Access Compliance Report
Public Rights-of-Way
(Curb Ramps)

Main Street: ORANGEWOOD_AVE | **Cross Street:** WALLINGSFORD_RD | **Location:** S

ADA ID: RPRK211215142609 | **Ramp Type:** Type 4 - Parallel | **Initial Pass/Fail:** Fail | **Overall Compliance:** No | **Severity Score:** 45

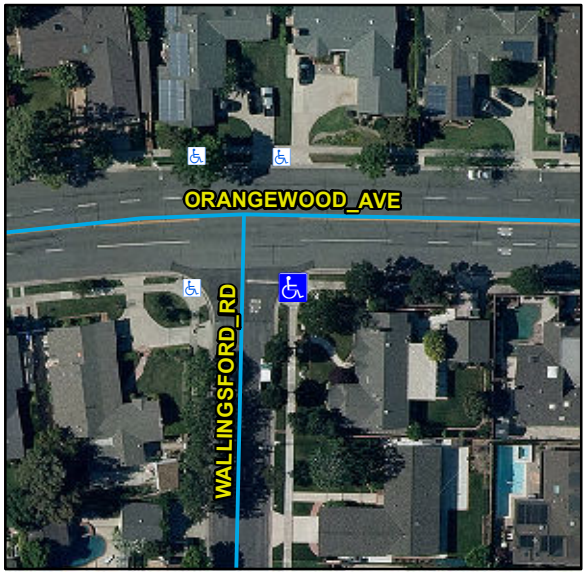
R204.3, R304.3.2, R304.5.3, STD 1115

Remove & Replace Curb Ramp With Two New Directional Ramps or Equivalent.
